Re: Second Submission Review: 64th Avenue Improvements E-470 to Jackson Gap – Infrastructure Site Plan
Application Number: DA-2205-00
Case Numbers: 2019-6049-00

Second Submission Review

SHEET: AER-039-PLAN

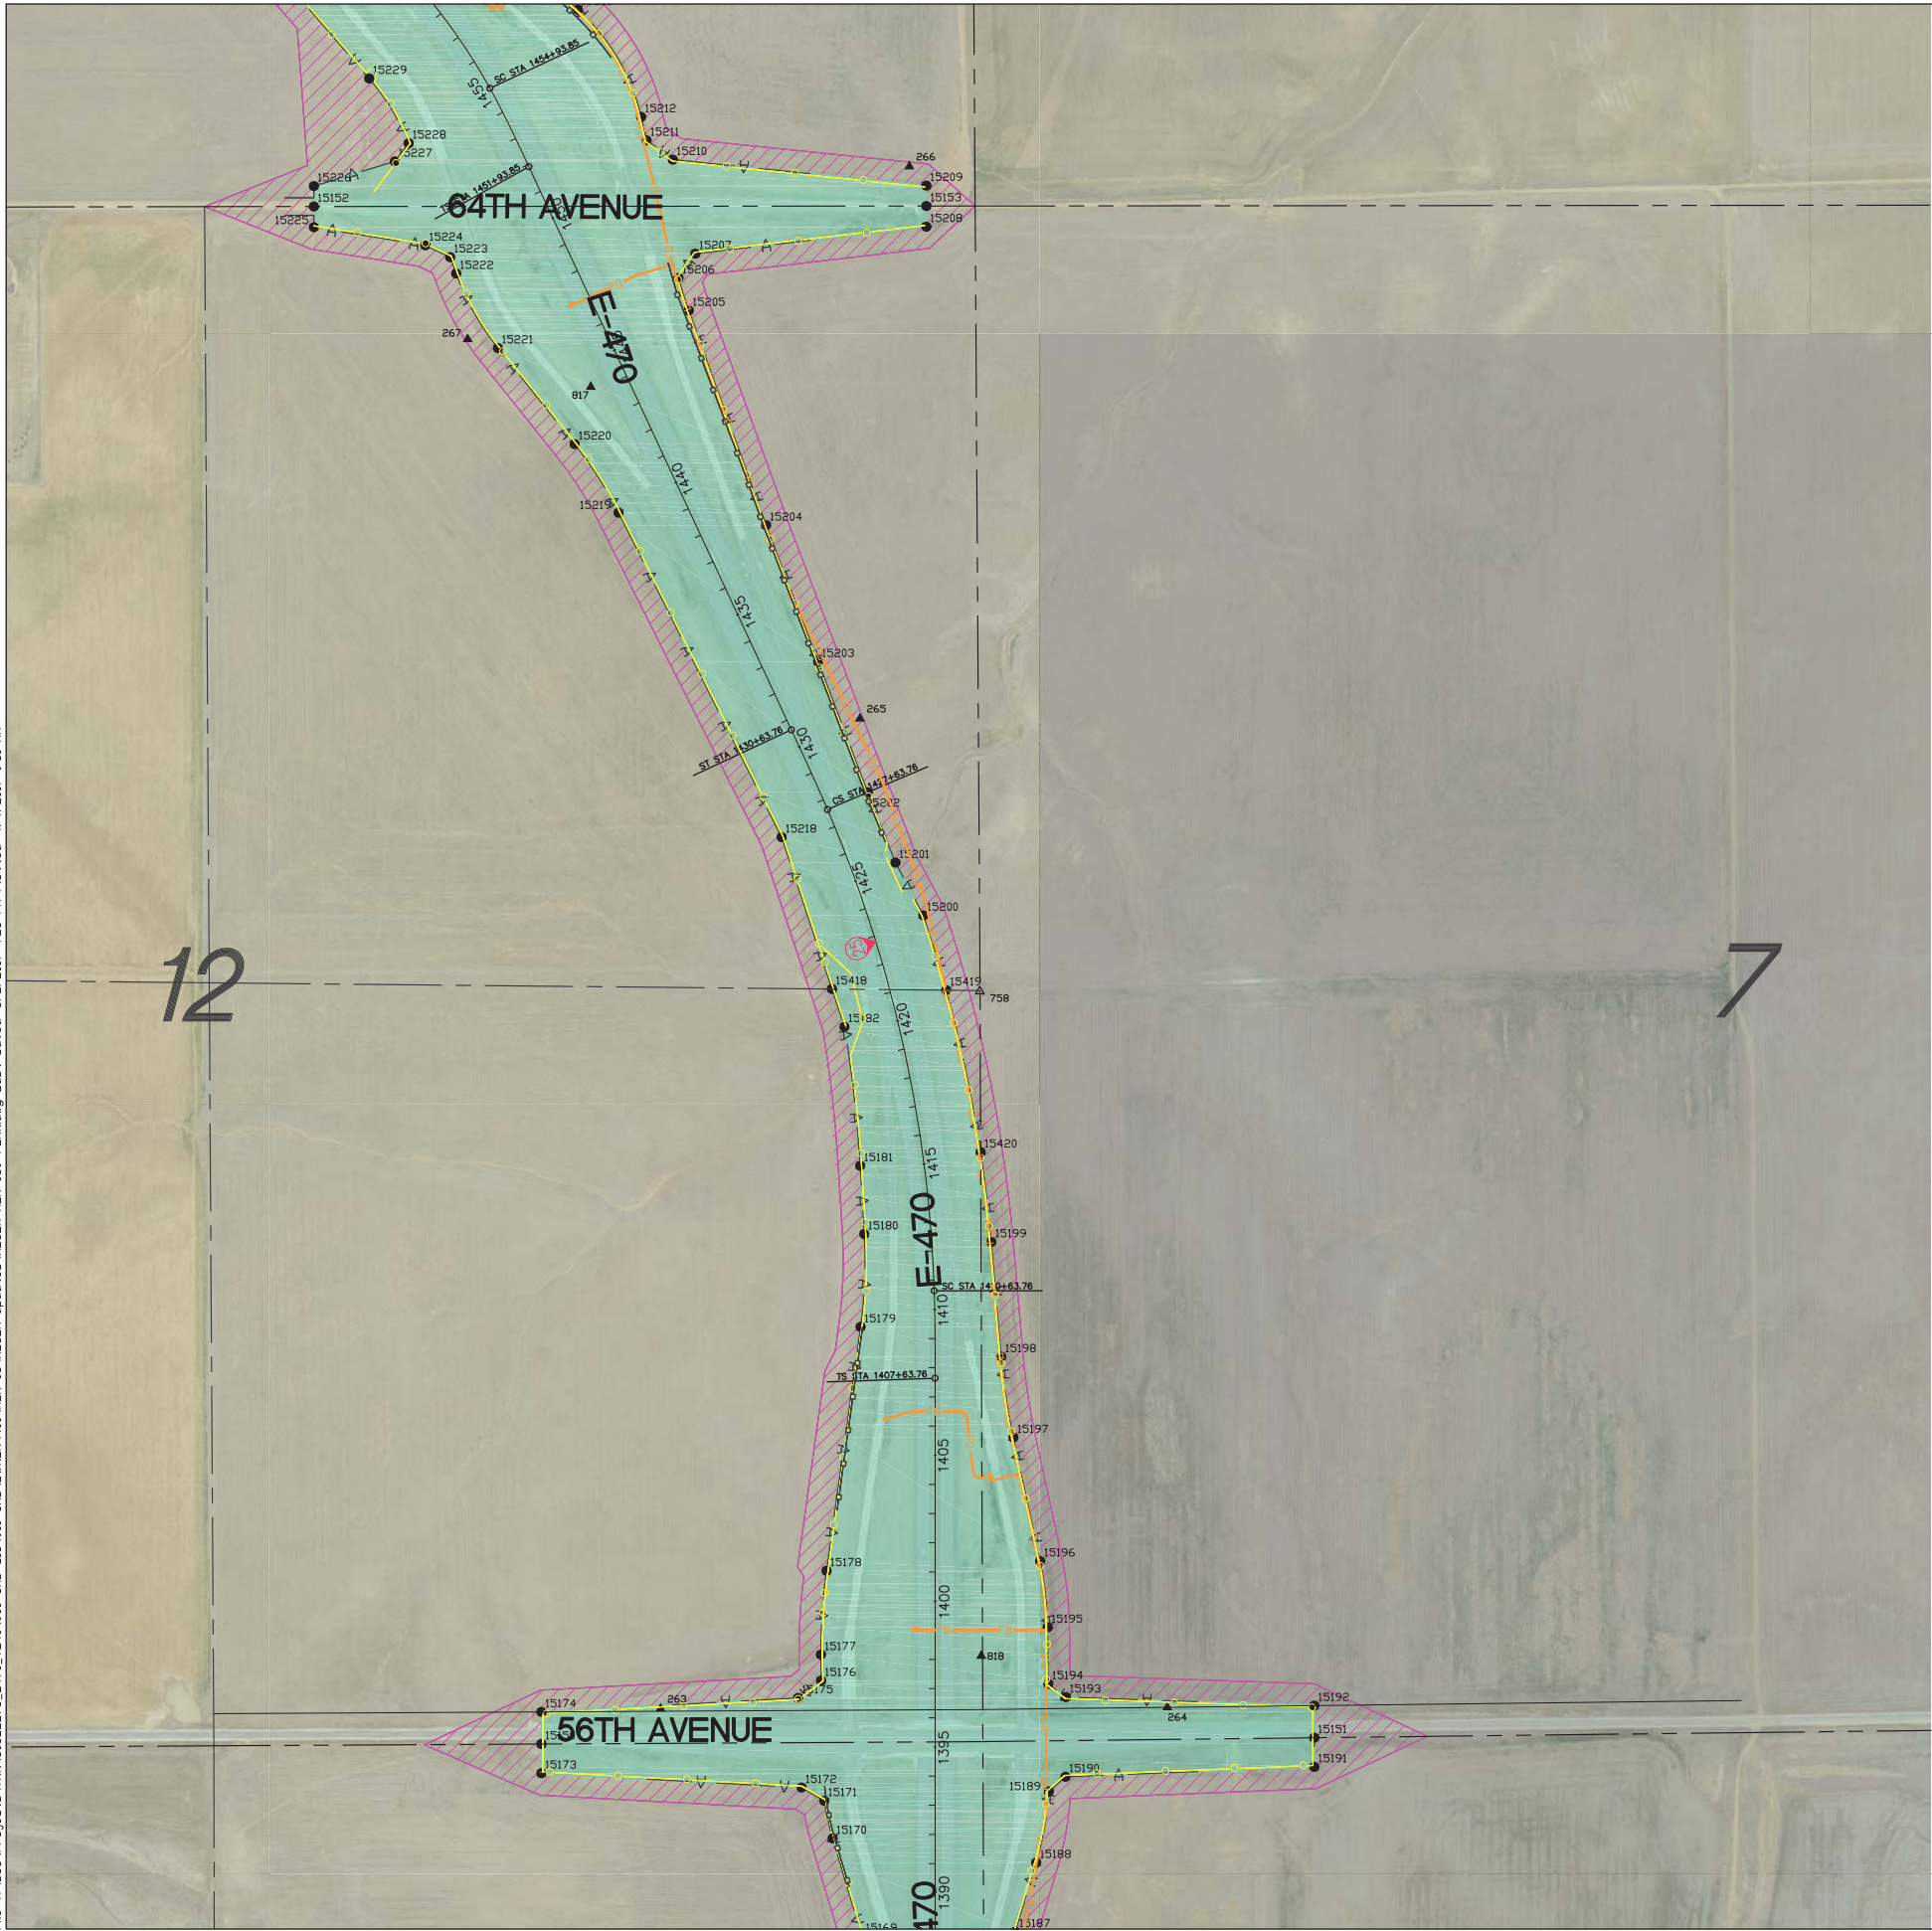
10B. It appears that the western portion of the Gun Club Road intersection falls within the Authority's MUE. Please label the limits in the plans. An ownership map has been attached for your reference.
